Metrolink - an Bord Pleanála Appeal

Living in the Canal Zone

Caitriona Shaffrey

25 March 2024

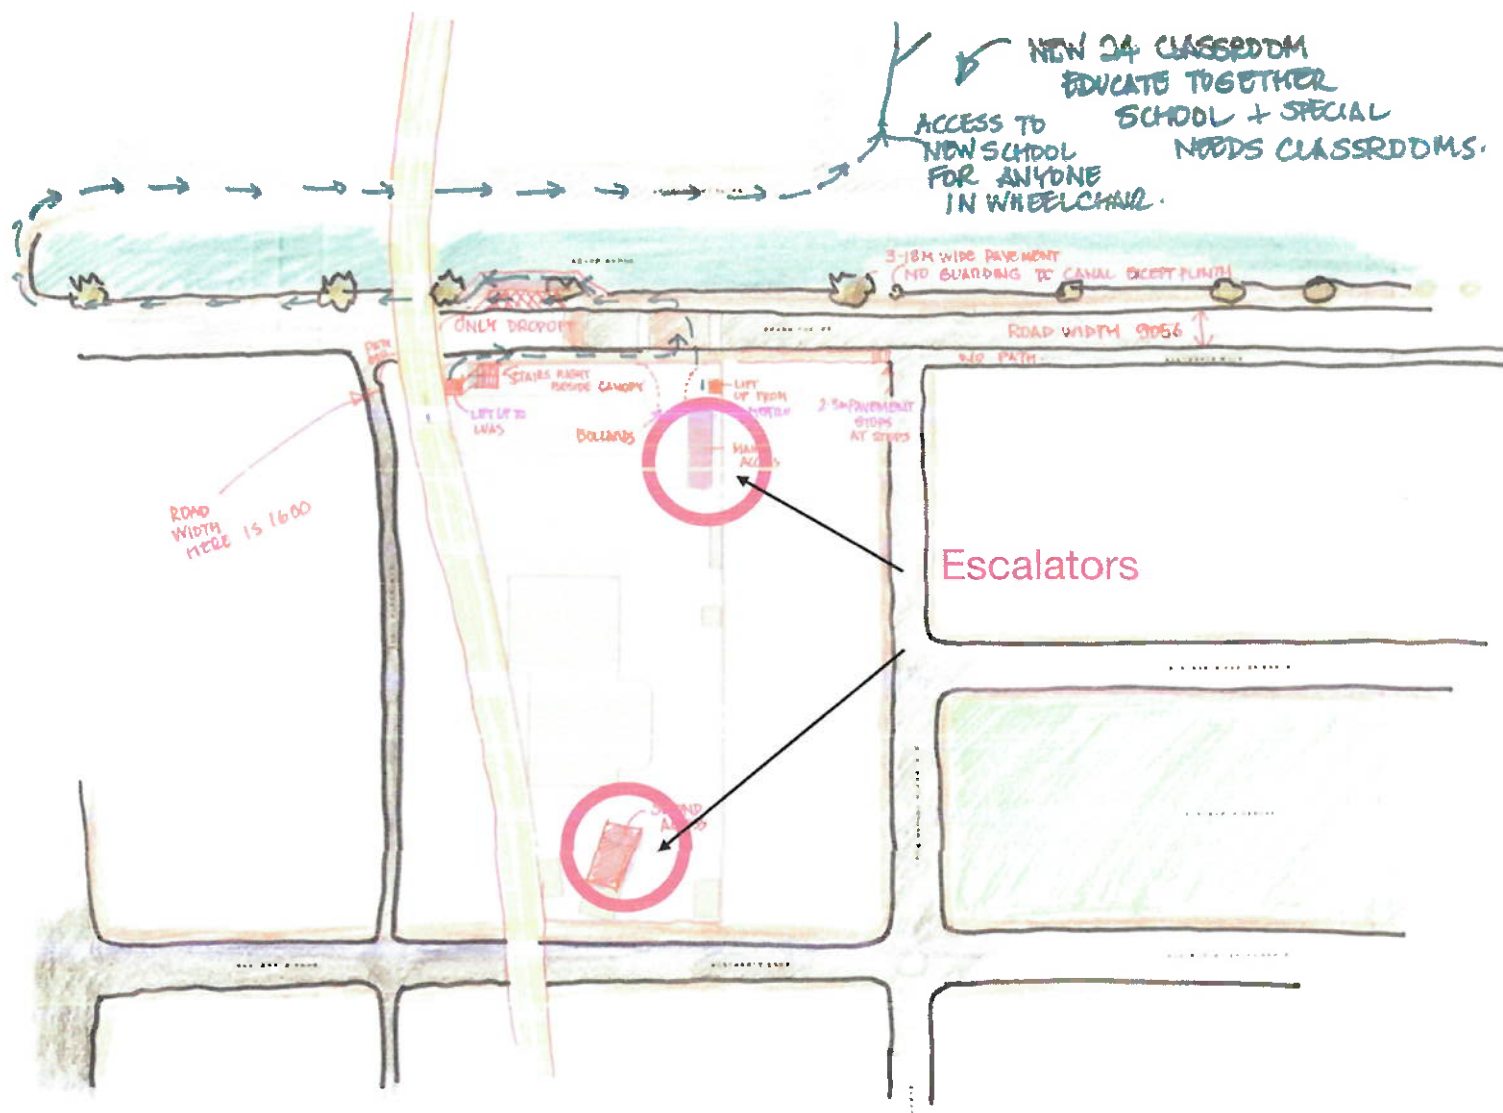
Canopy does not seem to appear on drawings

It may not look too well with main entry - and may need glass screen to canopy

Escalators

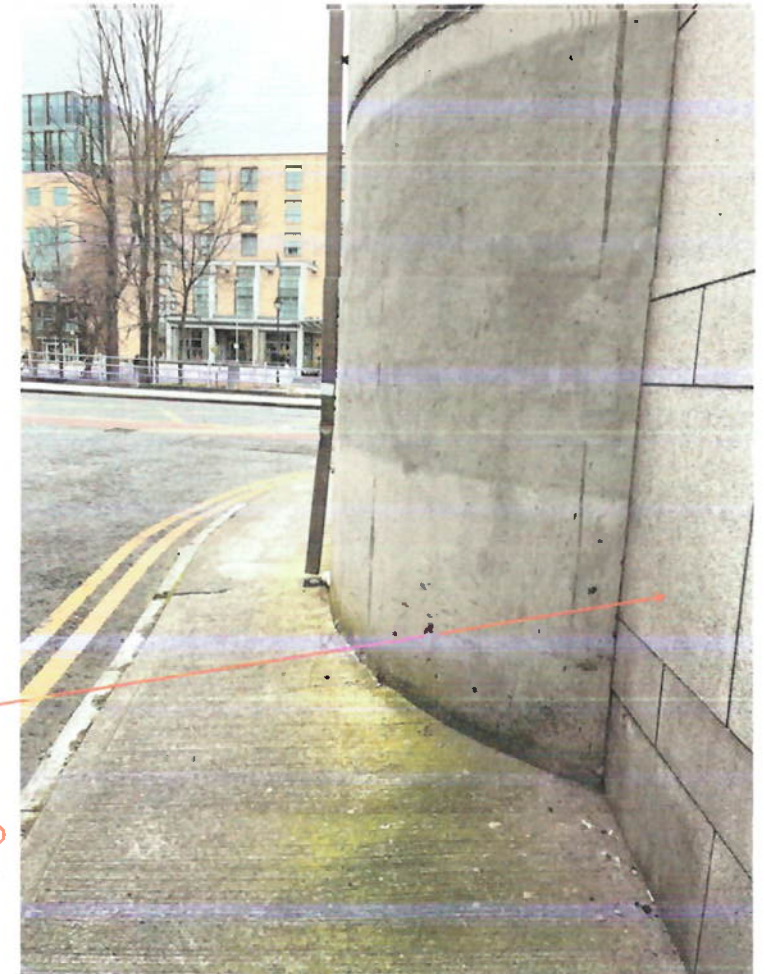
There is a new 24 classroom school+ special needs rooms being built across the canal as shown there are no set down spaces allowed for at the school and no parking except for bikes : children / teachers in wheelchairs would have to take route as indicated

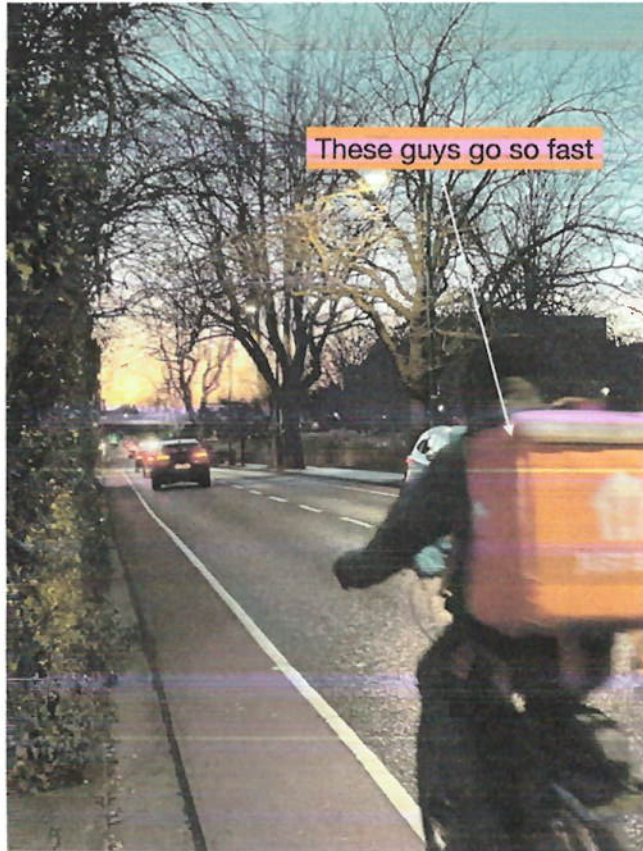
Building edge to
edge 1600mm

Showing how narrow the side lanes are - no place to park cars. very little private open space

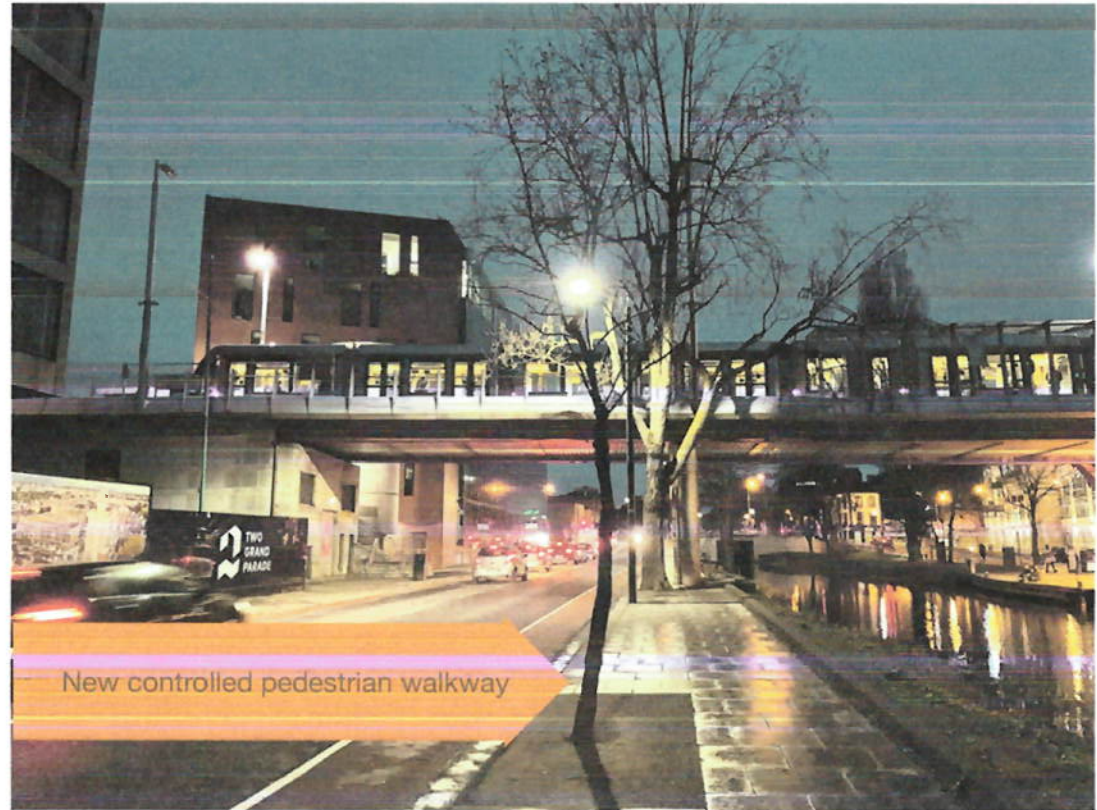
These guys go so fast

New controlled pedestrian walkway
